**BID ADDENDUM NO. 1**

PROJECT NAME: PORT CHESTER HIGH SCHOOL SUMP PUMP AND ATTIC CATWALK

DATE: September 27, 2021

PROJECT: PORT CHESTER-RYE UNION FREE SCHOOL DISTRICT  
PORT CHESTER HIGH SCHOOL  
BOILER ROOM SUMP PUMP  
1 TAMMANG RD, PORT CHESTER, NY 10573  
DRAWING TITLE: PART BASEMENT ELECTRICAL PLAN AND RISER

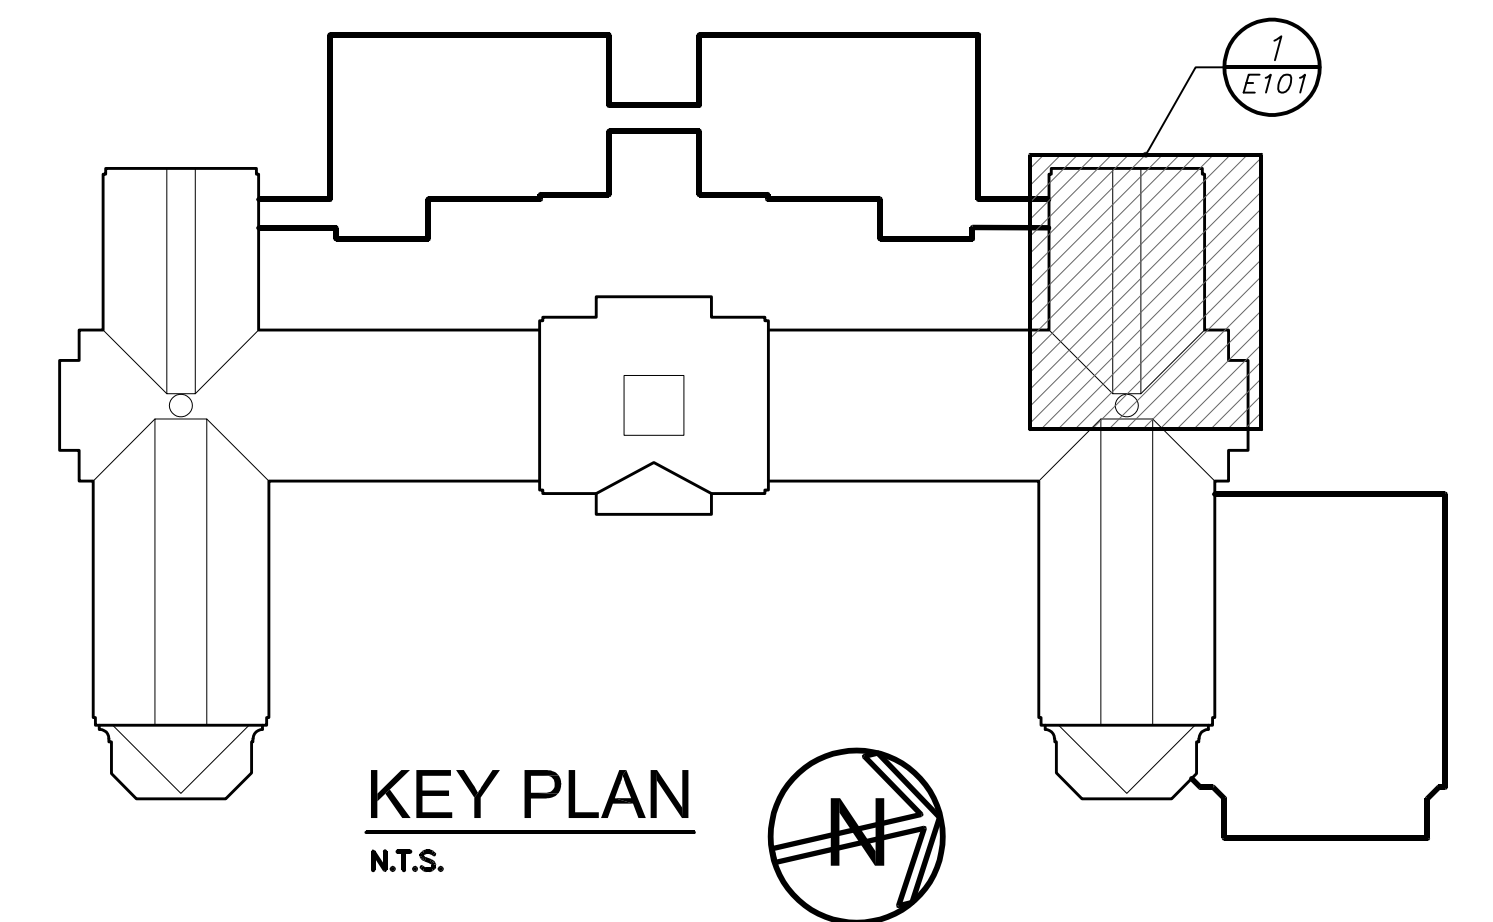
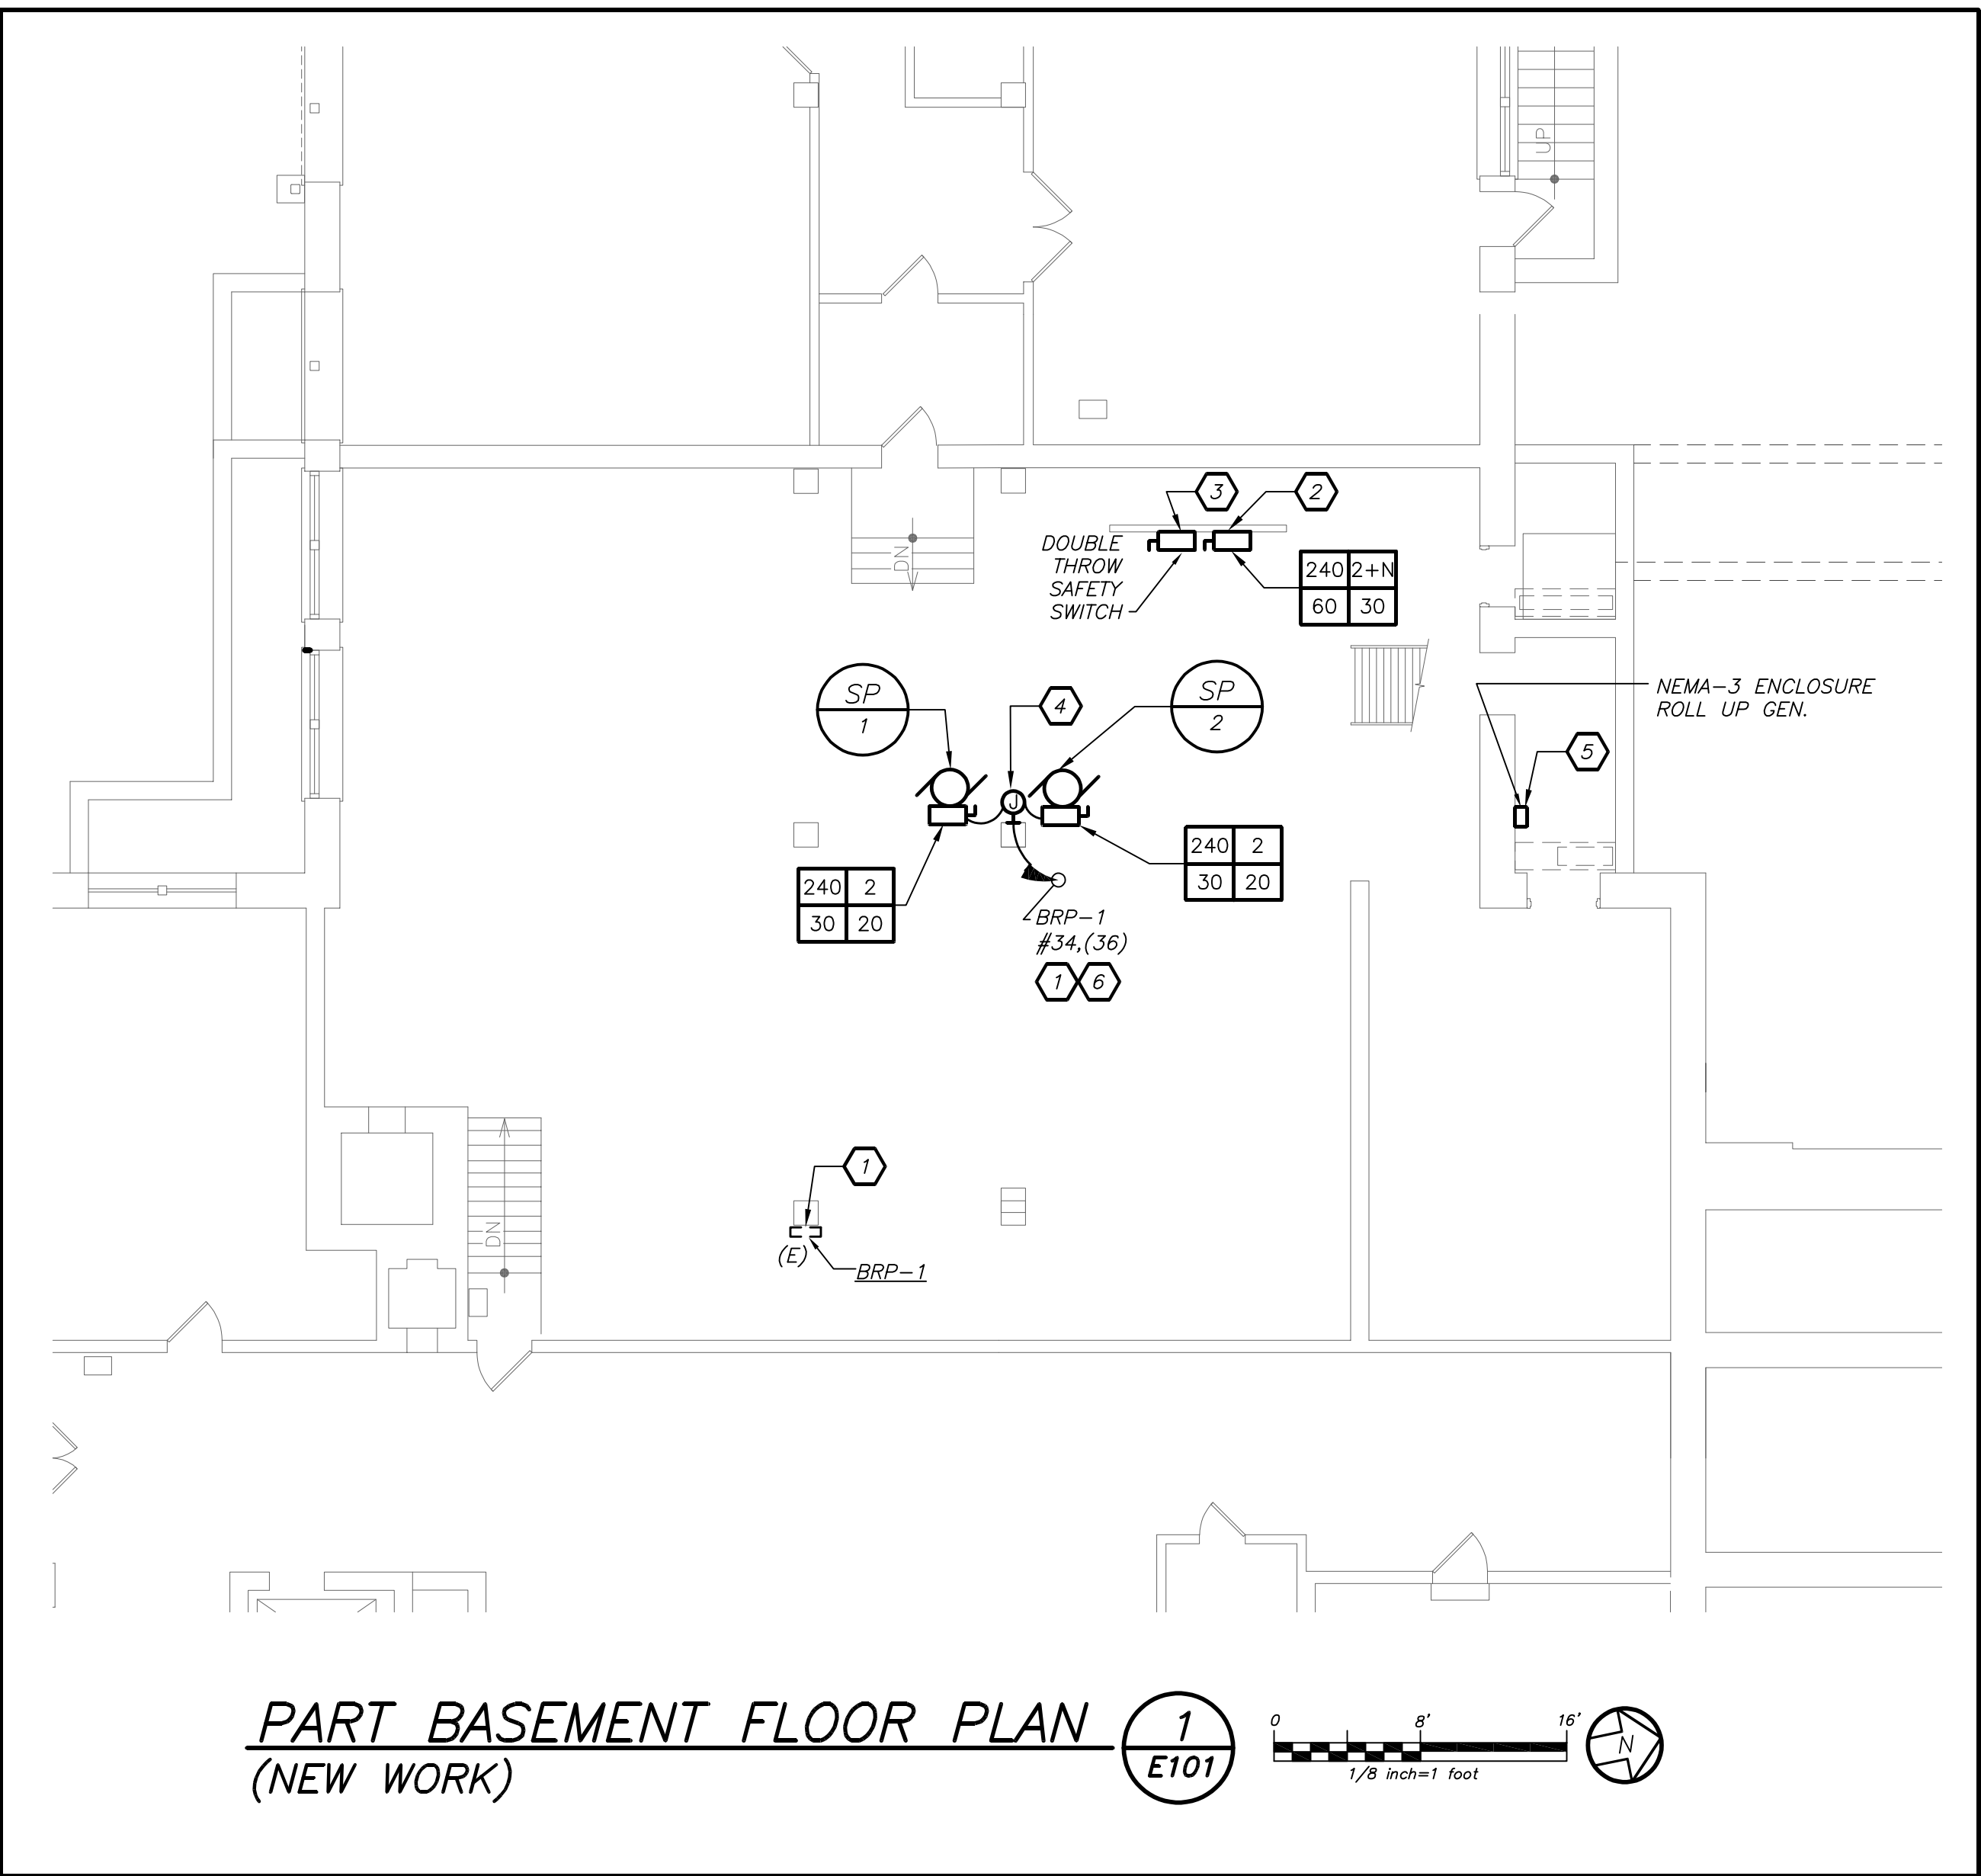
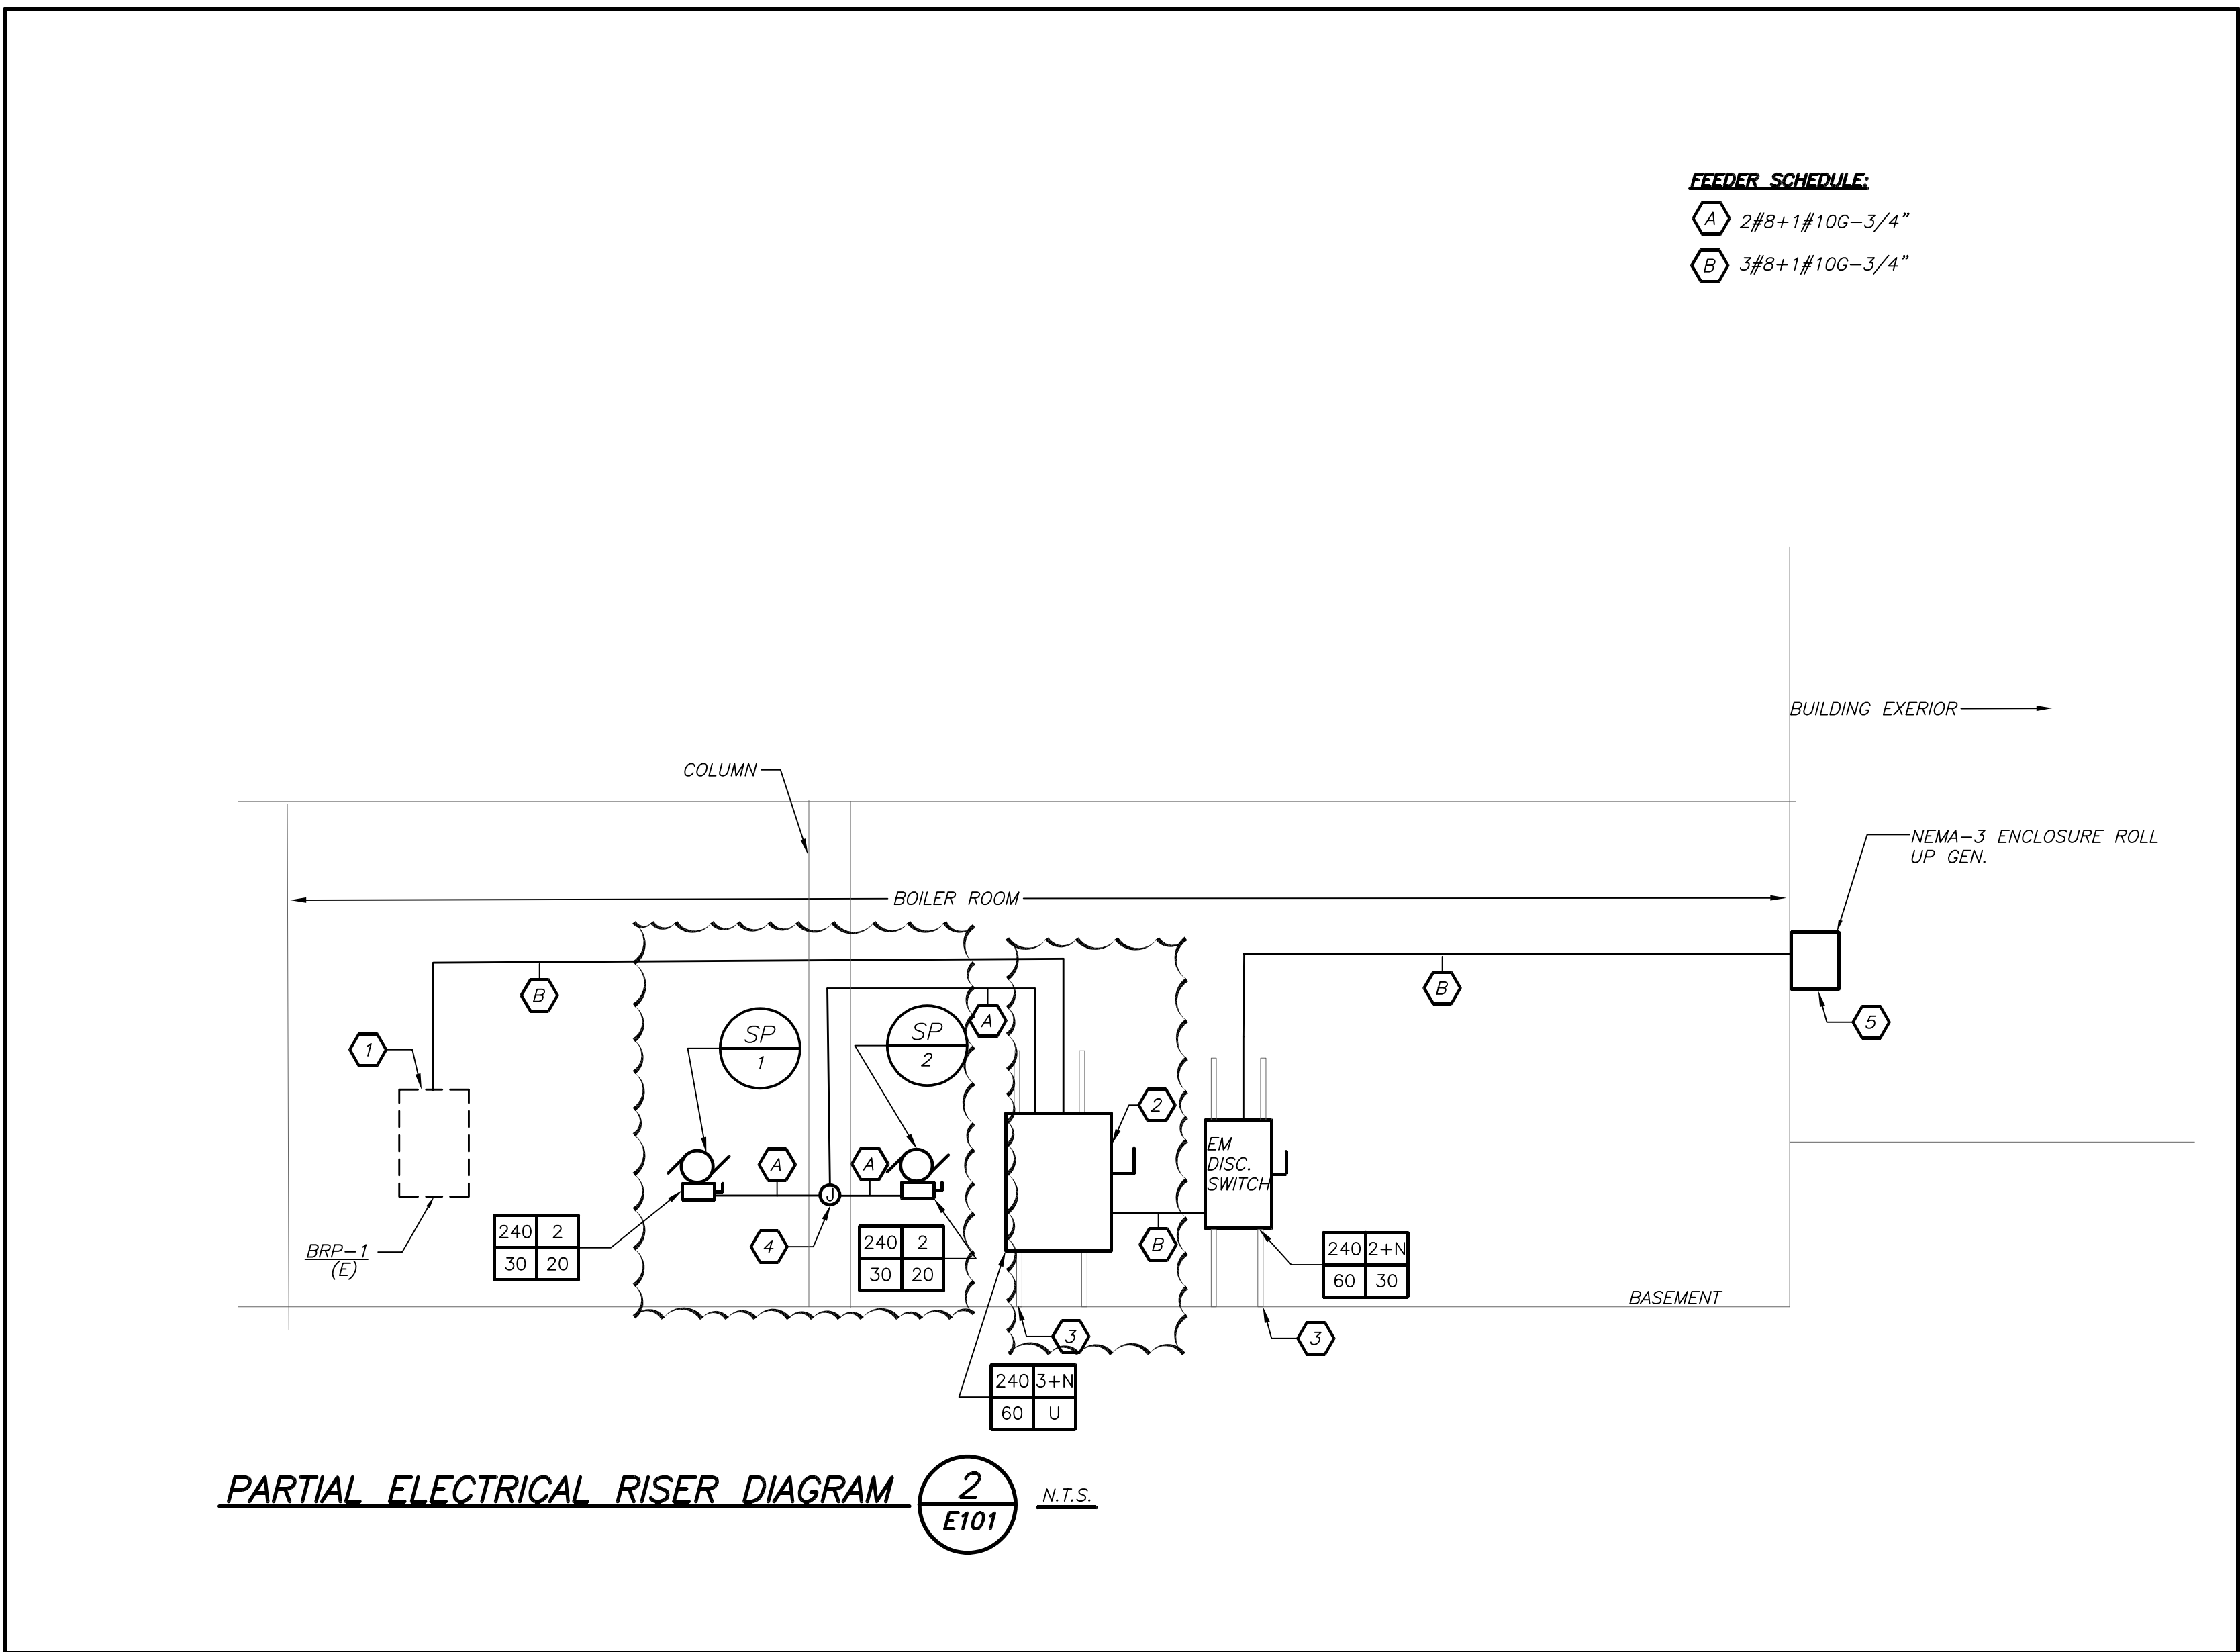
Refer to attachment for drawing PCHS E101 dated 9.24.2021 (revisions clouded).

- 1 PROVIDE 2#8+1#10G IN 3/4" CONDUIT TO CIRCUIT AS SHOWN. PROVIDE A 2P-30AMP BREAKER IN AVAILABLE AT PANEL BRP-1
- 2 PROVIDE A 60 AMP GE DOUBLE THROW FOUR WIRE 240 V SAFETY SWITCH MODEL # TC35322 WITH DS100GK GROUND KIT AND TNR100 NEUTRAL KIT. ONLY USE PHASE "A" AND "B". PHASE "C" WILL NOT BE USED.

- 3 PROVIDE KINDORF SUPPORT FOR EQUIPMENT.
- 4 PROVIDE A TRIPLE GANG BOX. BOX SHALL BE MOUNTED ON WALL.
- 5 PROVIDE WEATHERPROOF HUBBELL TWIST-LOCK PLUG RATED AT 125V/250V 30 AMPS PART # HBL2711 AND HUBBELL HBL2713 TO MATCH EXISTING PORTABLE GENERATOR OUTPUT RECEPTACLE. CONNECT WITH 3#8+1#10G GRD. PROVIDE A NEMA-3R INLET BOX HUBBELL PART # HBL2715M3. INLET BOX SHALL BE MOUNTED ON EXTERIOR WALL. PROVIDE WATER TIGHT BOX HUBBELL BOX PART # HBL6083 PROVIDE ALL REQUIRED AND NECESSARY ACCESSORIES. PROVIDE WEATHERPROOF 2 GANG DEEP BOX WITH A LOCKABLE HINGED COVER. COORDINATE EXACT LOCATION OF ENCLOSURE AND OUTLET CONFIGURATION WITH OWNERS BEFORE THE START OF ANY WORK.

- 6 SUMP PUMP POWER SHALL BE FED FROM MANUAL DOUBLE THROW SAFETY SWITCH. REFER TO RISER DIAGRAM FOR ADDITIONAL DETAILS.
